8/20/18 - sheets 4 & 5 added w/ proper finish on 2nd floor  
 9/20/18 - shelving corrected  
 11/5/18 - corrected 6A - (20" LVL)  
 12/12/18 - Added tub Deck 1st Floor Master (Platform tub)  
 12/28/18 - 6A corrected to match Truss plan posted 1/19

**COVER SHEET**

**INVENTORY PROJECT**  
 LOT 8 - 13 TH AVE.  
 SAFETY HARBOR, FL.

**MODEL 2844**

SECOND FLOOR

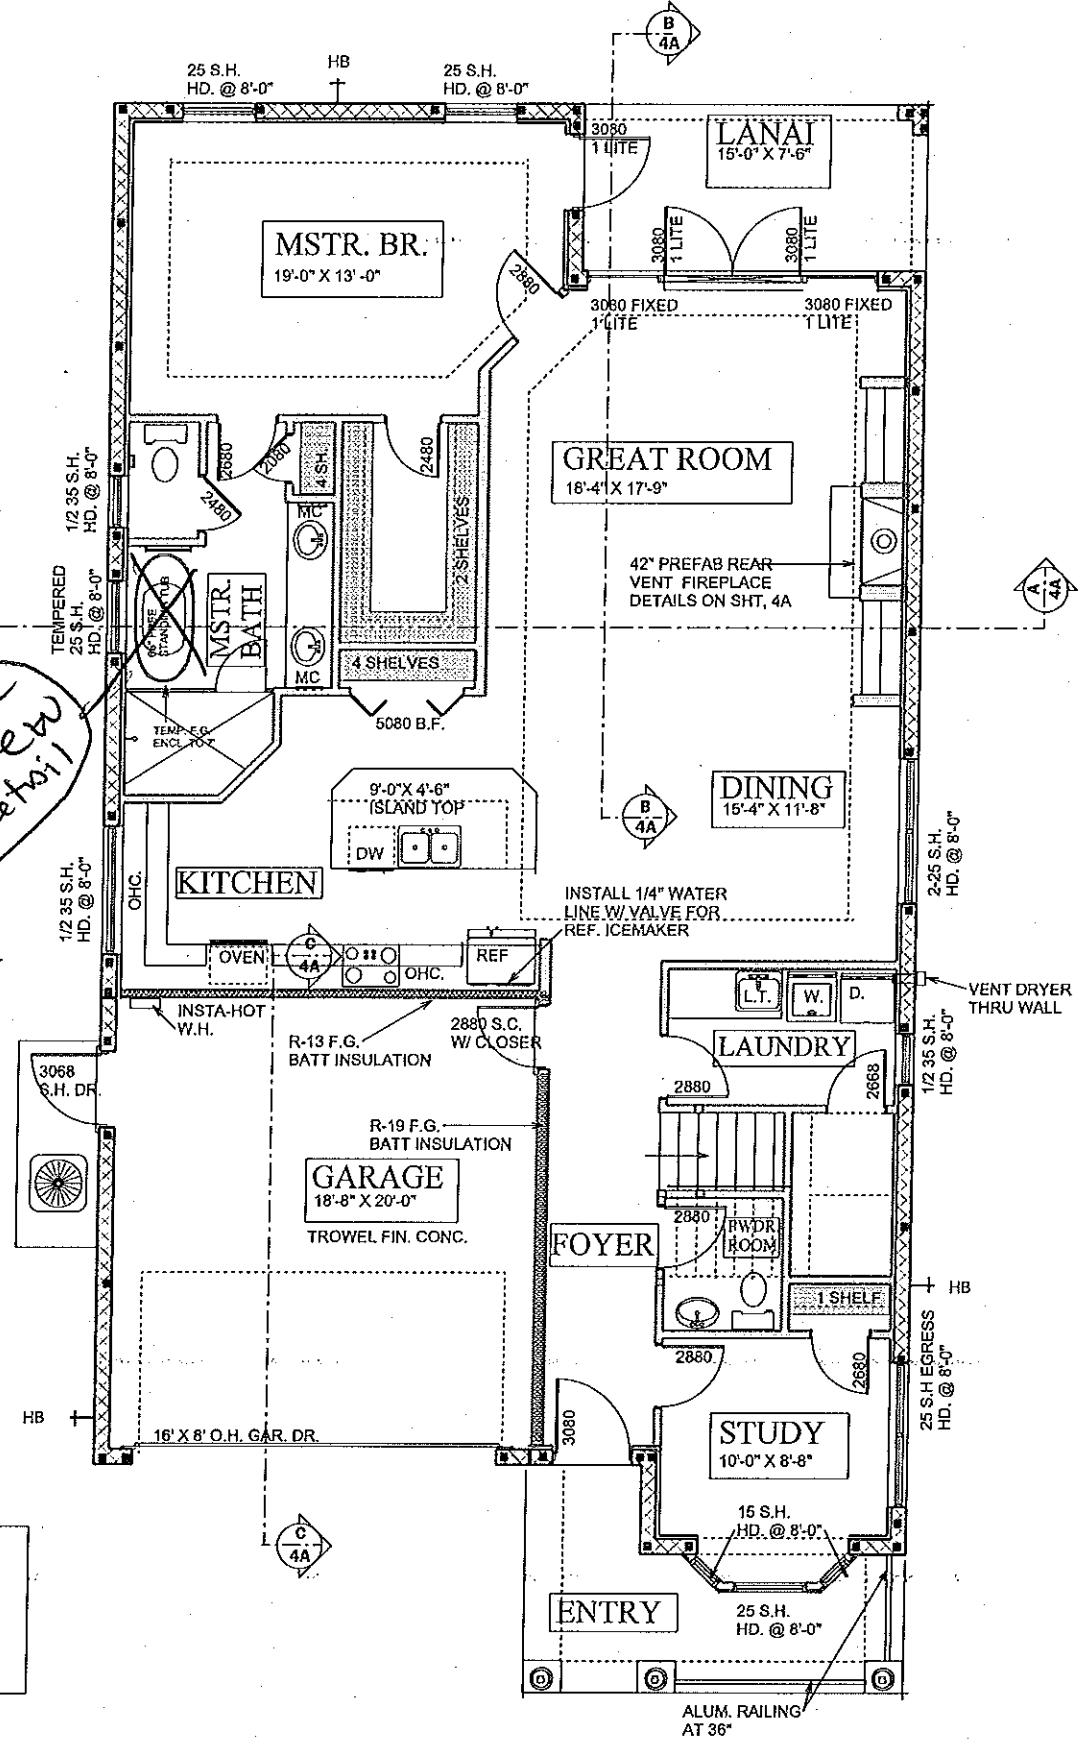
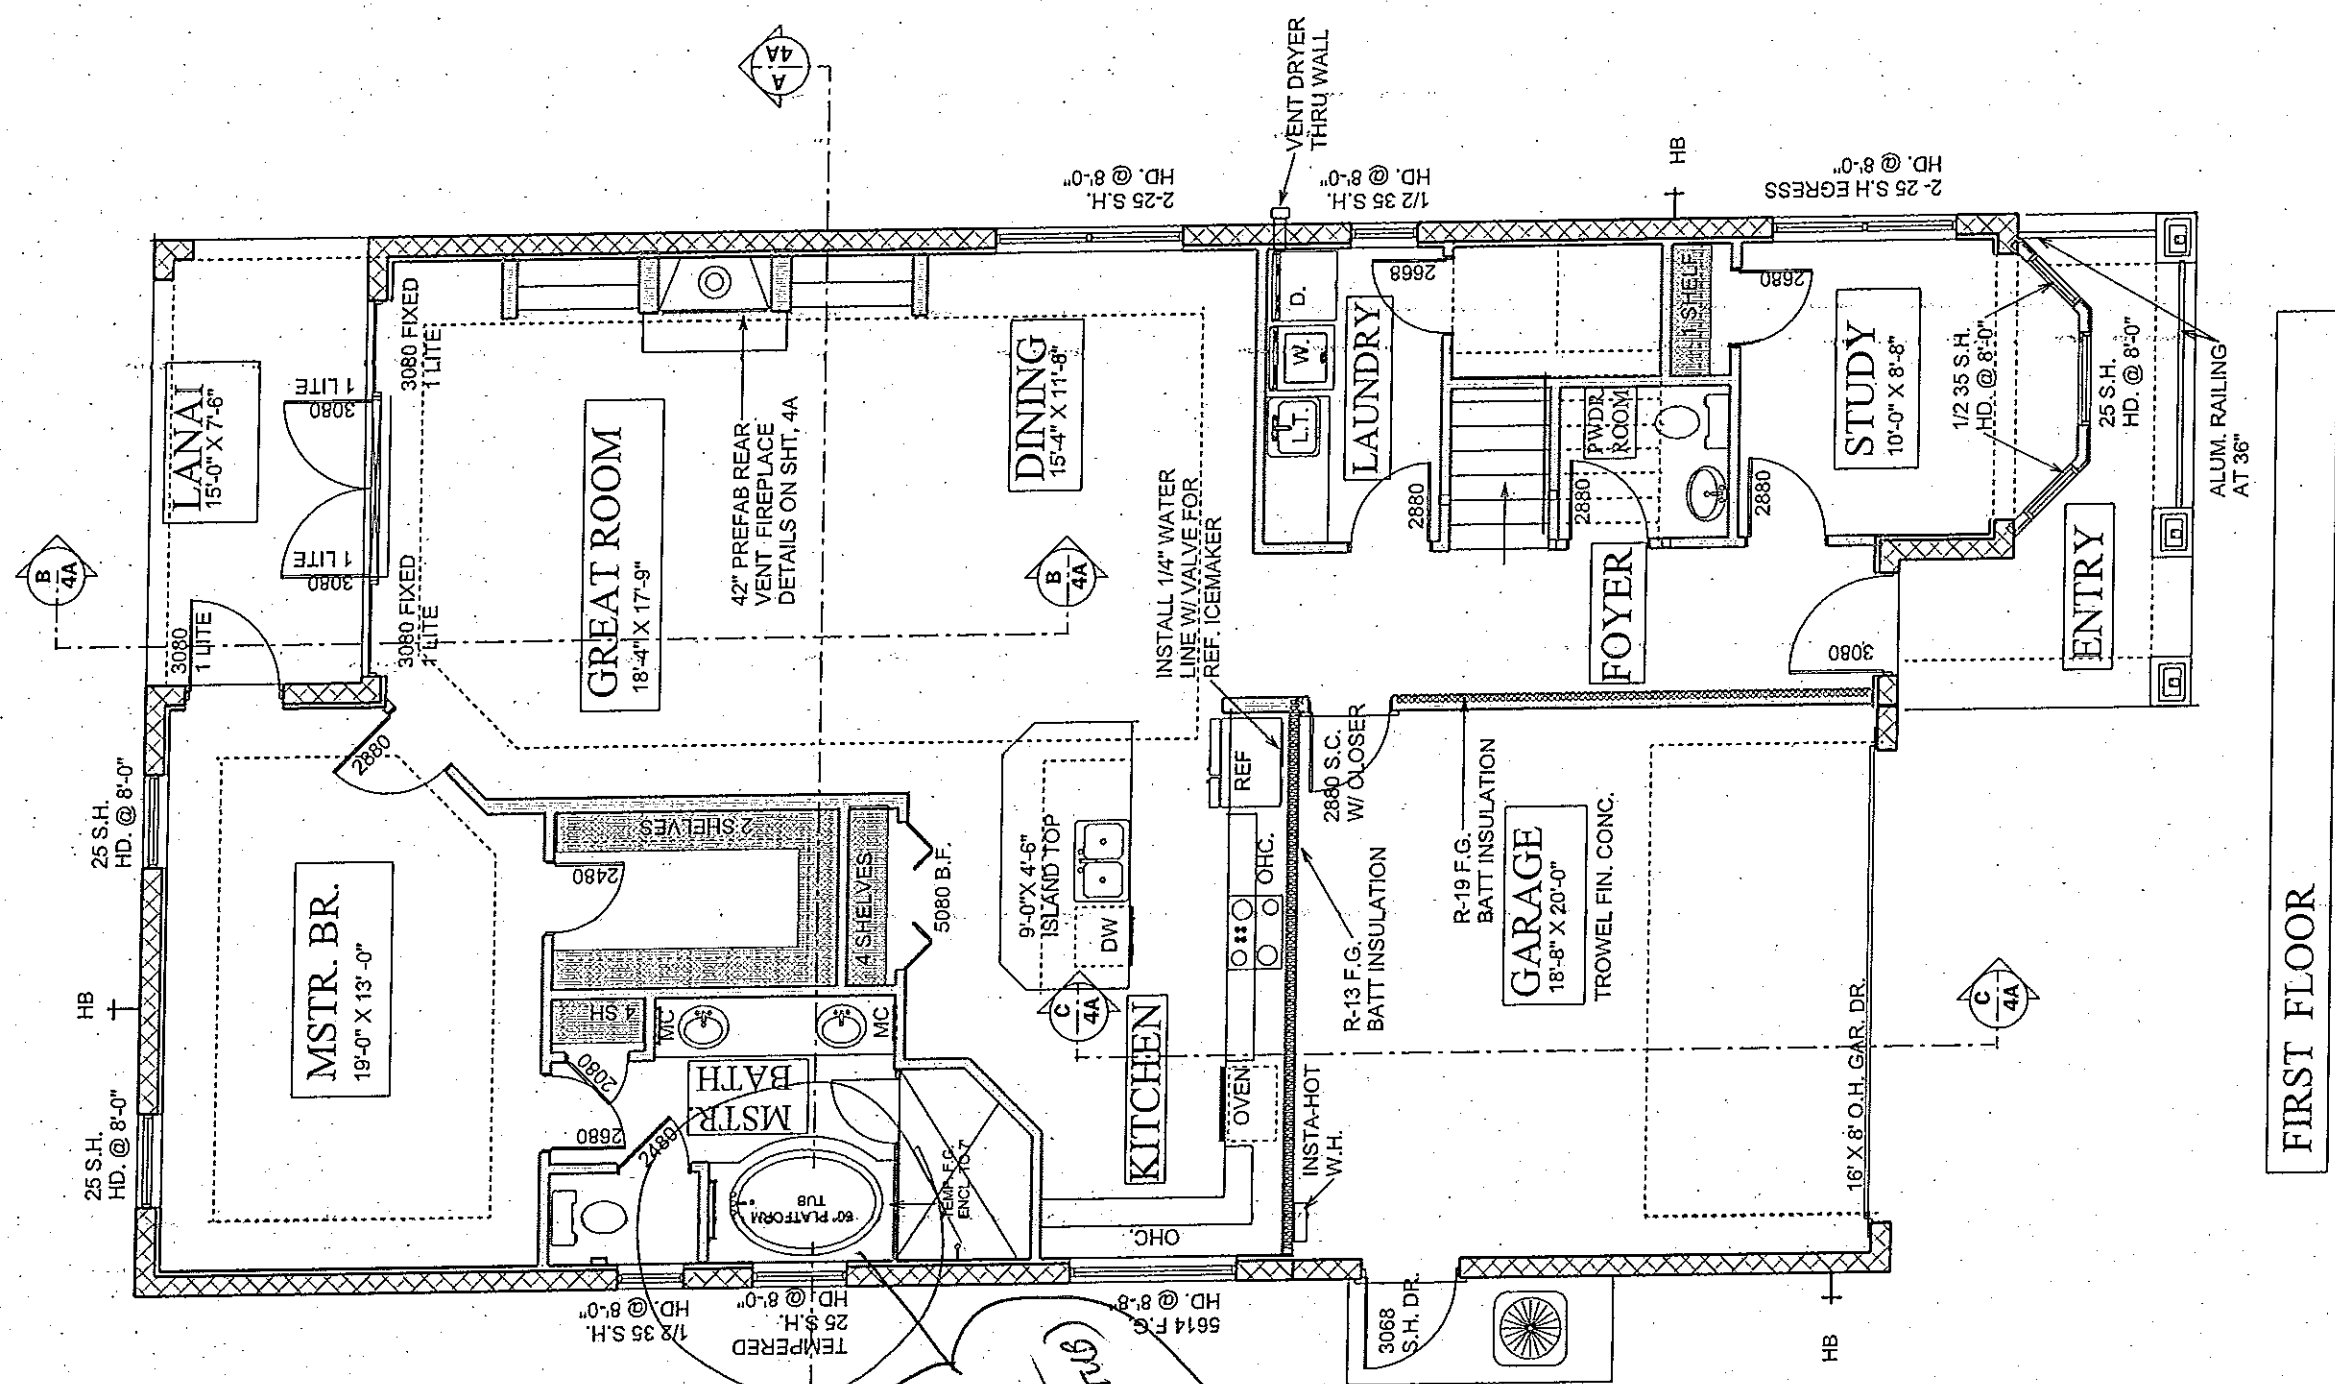
*See New Tub Detail 2A*

*Handwritten note:* (P/A) TRAVELING Deck TUBS new

DIMENSION PLANS

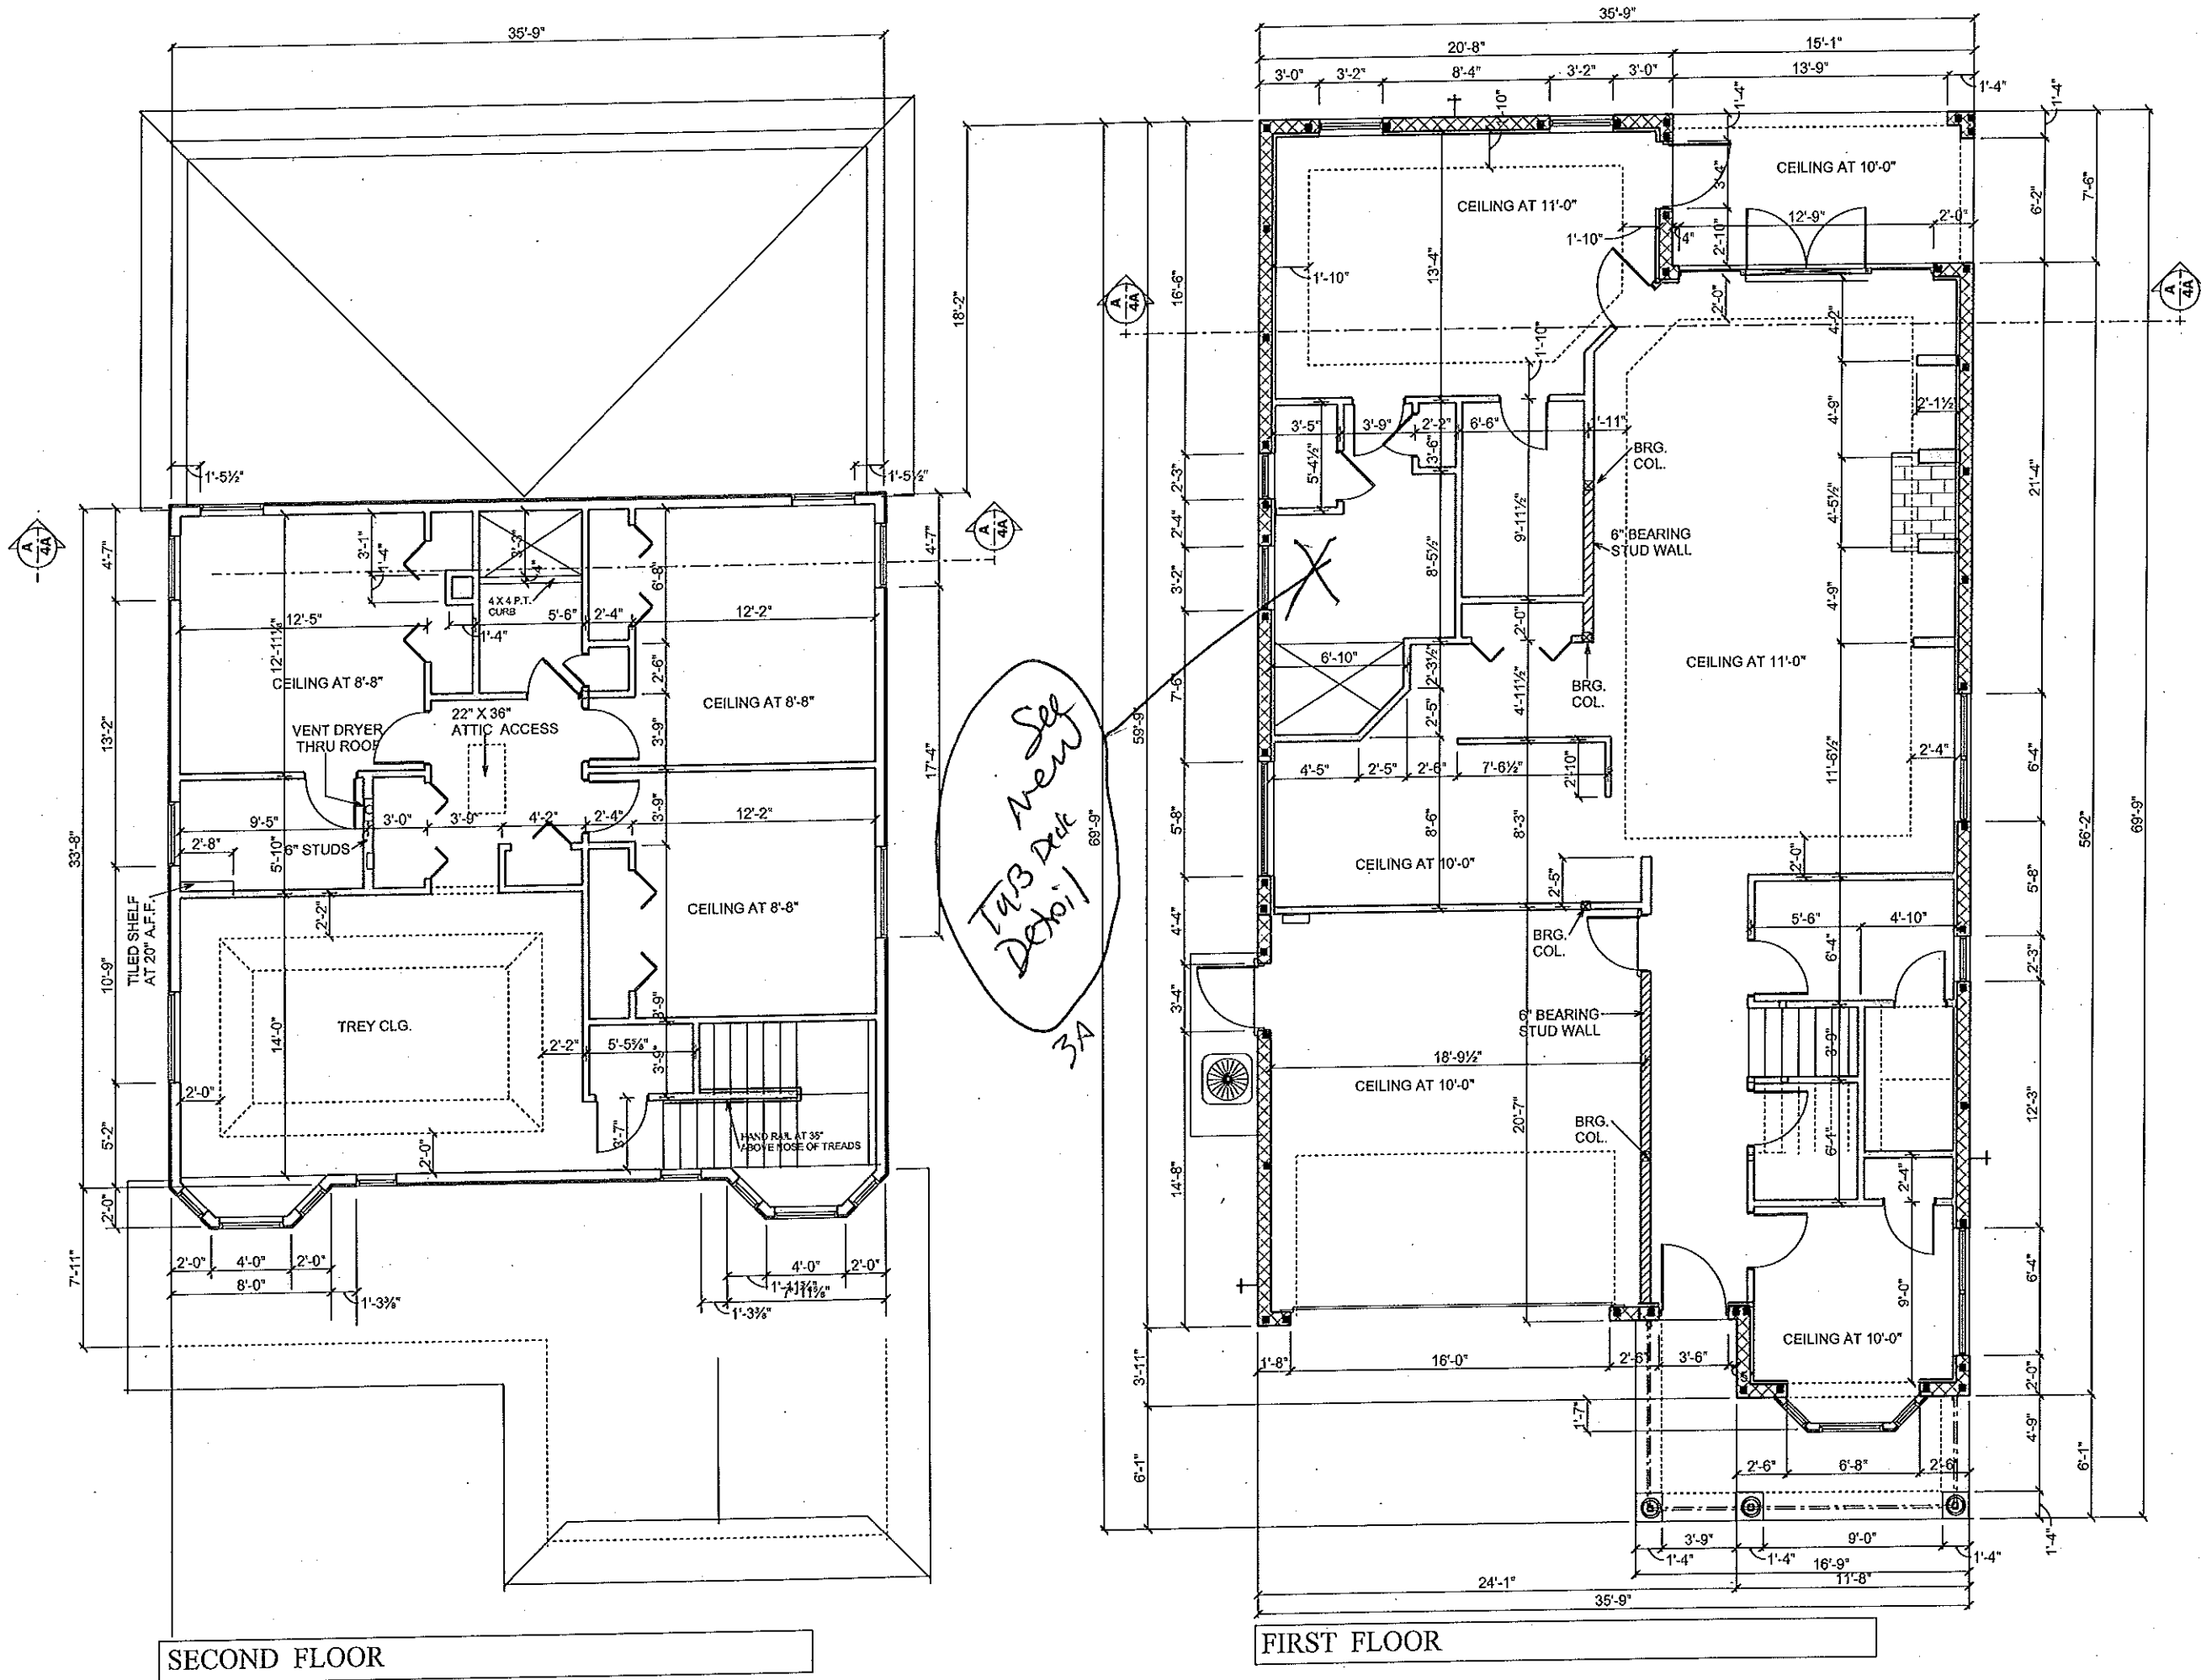
*Handwritten note:* Added TUB Deck 2A
